CITY OF ALBUQUERQUE

**RE: Lot 8A Block 5 Volcano Cliffs Unit 18 SAD 228
8004 Compass Dr. NW
Grading and Drainage Plan
Engineers Stamp Date 10/11/2020 (D10D003K8A)
Pad Certification Date 11/6/2020**

ENGINEER'S SEAL	LOTS 8A & 8B BLK 5 U 18 VC 8004 COMPASS DR NW		DRAWN BY DEM
	GRADING AND DRAINAGE PLAN		DATE 10-10-20
DAVID SOULE P.E. #14522			8A 8B BLK 5 U 18 VC.DWG
			SHEET # C1
			JOB #

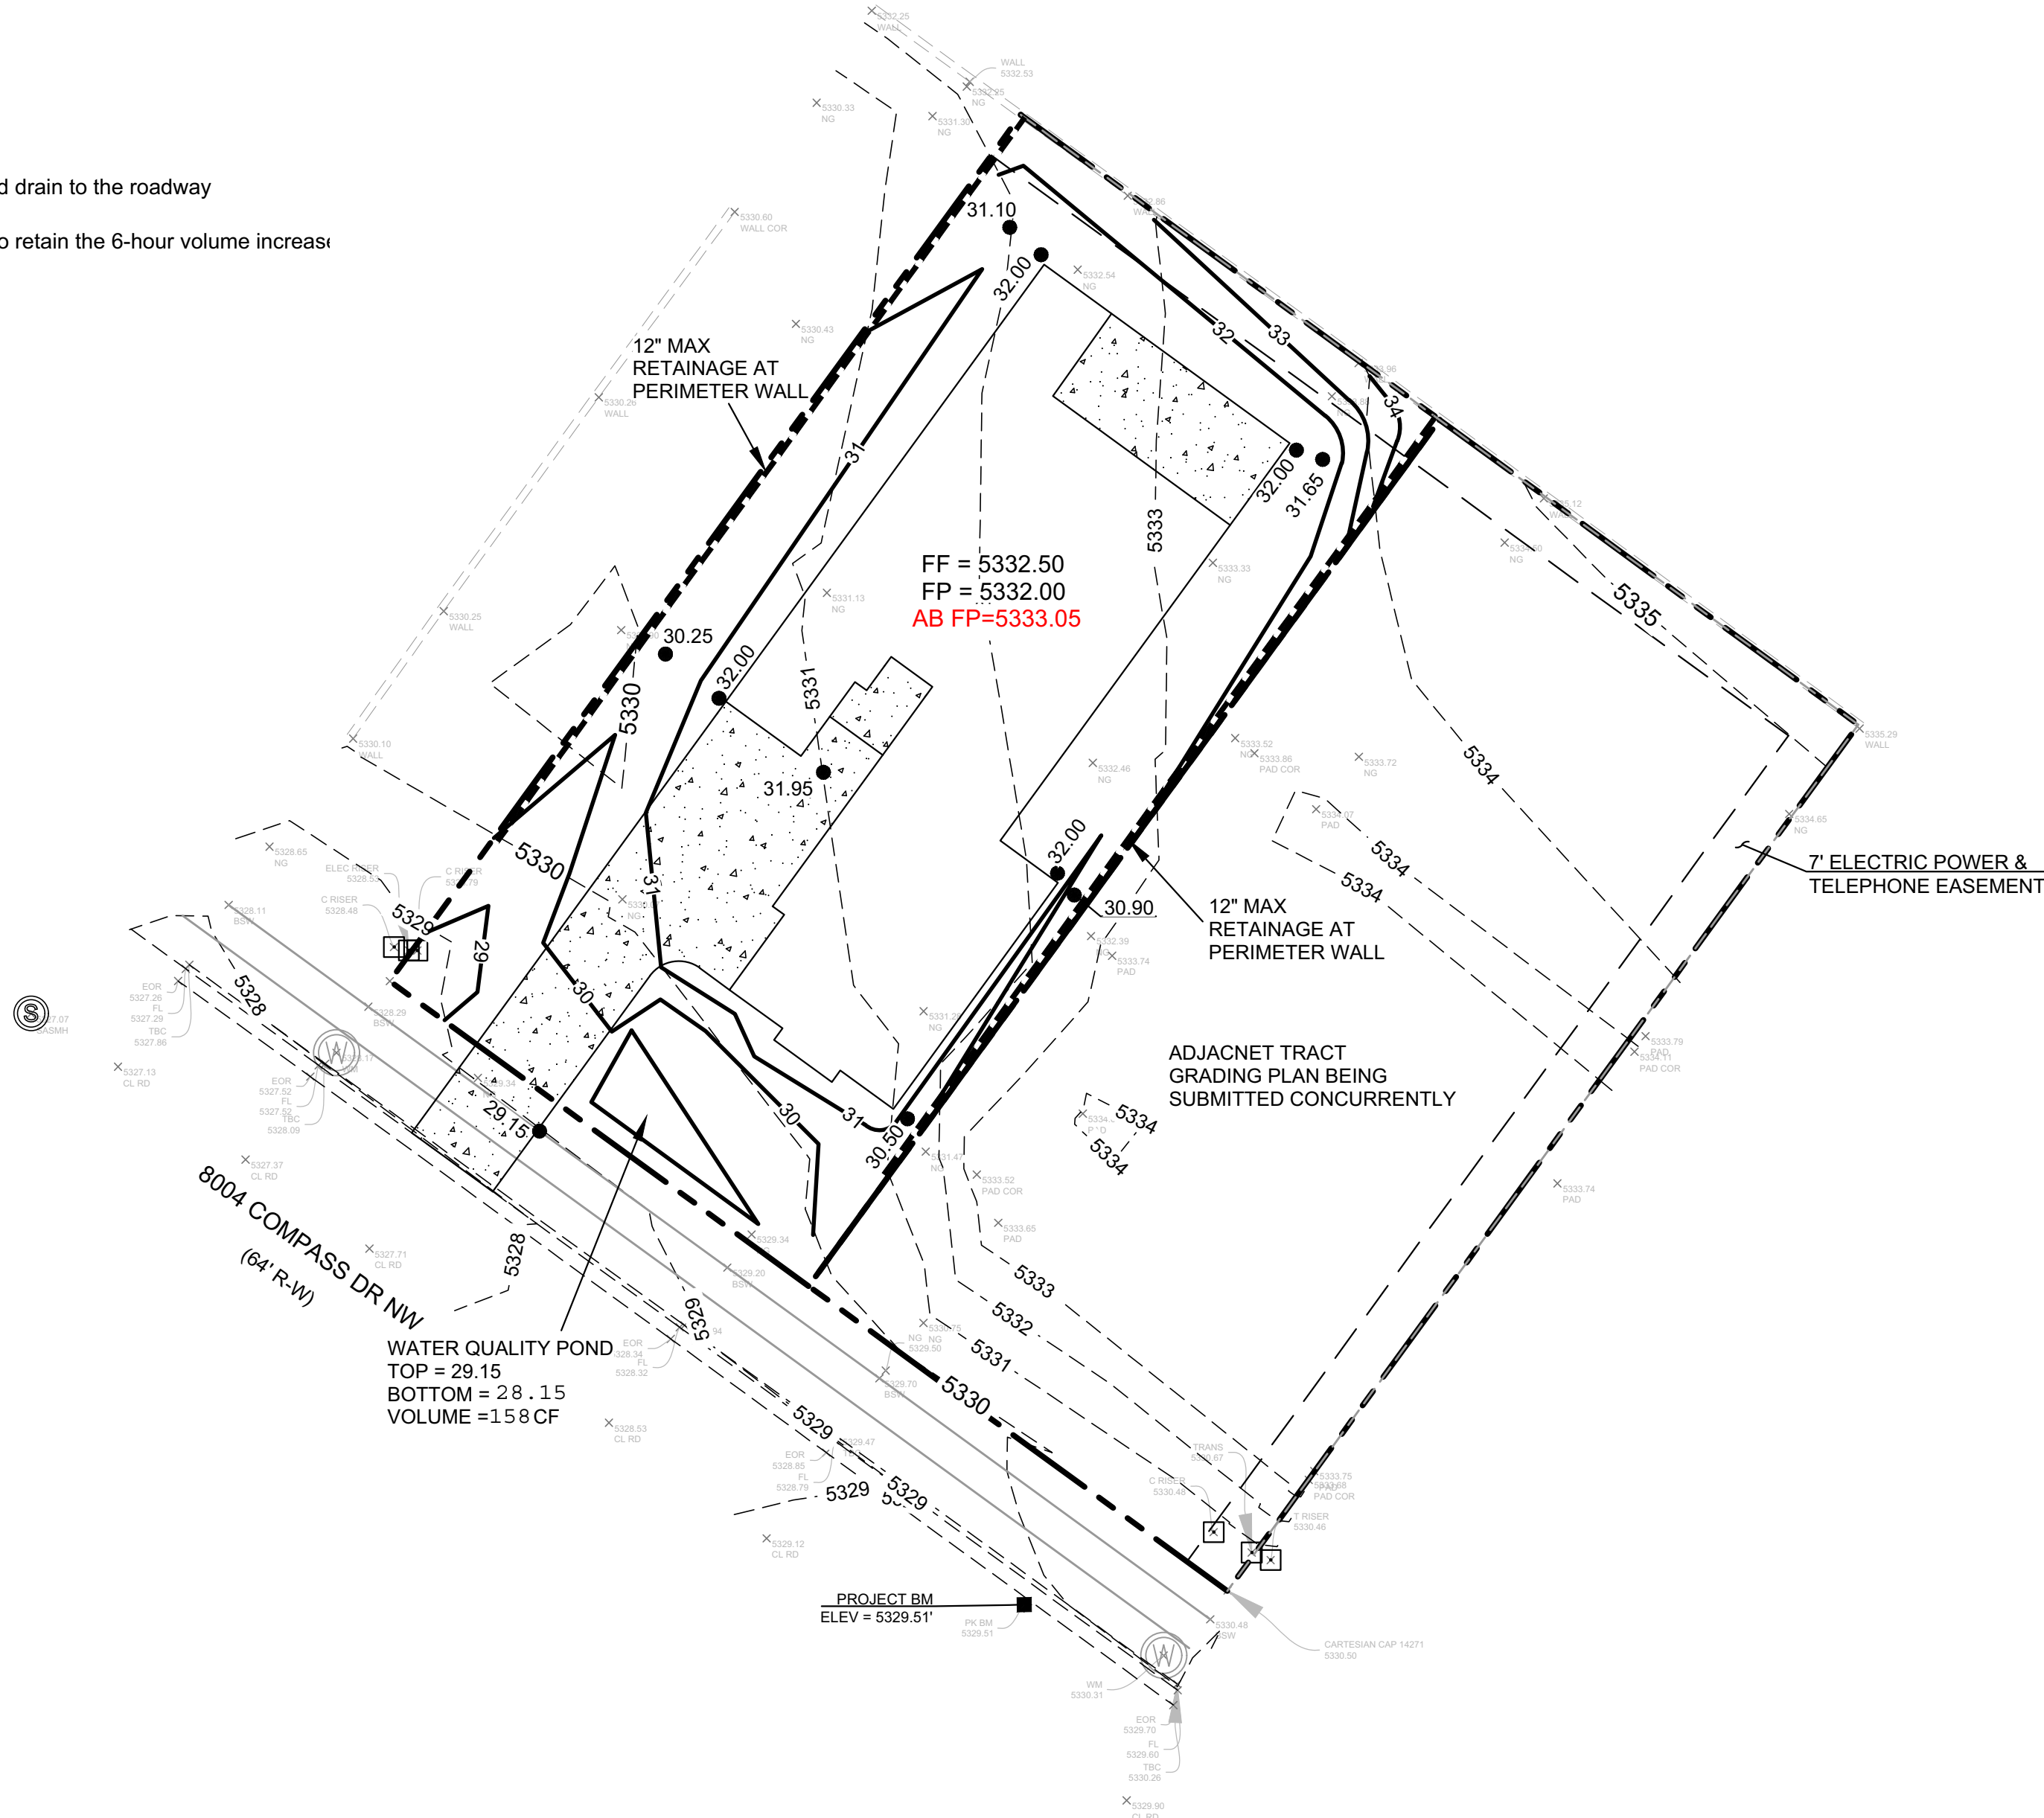
Based upon the information provided in your submittal received 11/9/2020, this plan is approved for Building Permit.

Please inform the builder/owner to attach a copy of this approved plan and this letter to the construction sets in the permitting process prior to sign-off by Hydrology.

Reiterate to the Owner/Contractor that a separate permit for a garden/retaining wall must be obtained, with the approved G&D plan dated 3/15/2020 and Pad Certification Date 9/14/2020.

Prior to Certificate of Occupancy release, Engineer Certification per the DPM checklist of this plan will be required.
